AGENDA ITEM SUMMARY

August 7, 2017

Consider a request for approval to the Subdivision Ordinance, Article 3, Section 3.02.003 Street Cross Section Standards for the 145.51 acres Subdivision. Take necessary action.

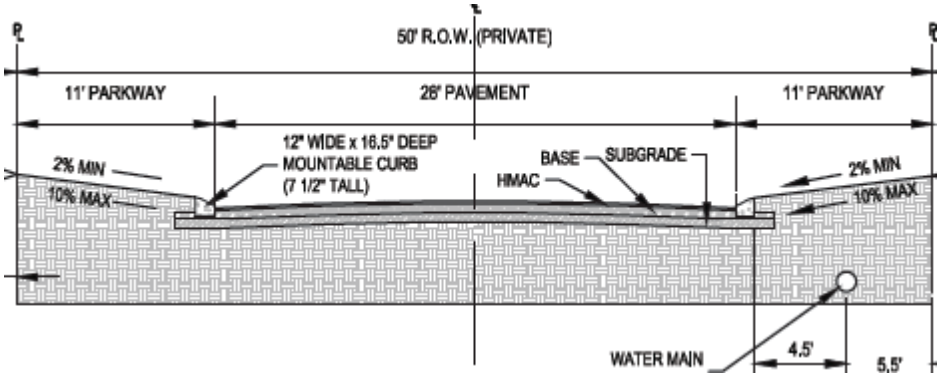
The developer has requested a different cross-section than is provided by our ordinance, therefore it does require P&Z and City Council approval.

The developer would like to build an acreage lot community in a rural setting, but would like to provide a “cleaner” street layout than streets with no curbs and borrow ditches. Below is the typical city rural street cross-section compared to what the developer would like to build. Staff is supportive of the proposed cross-section.
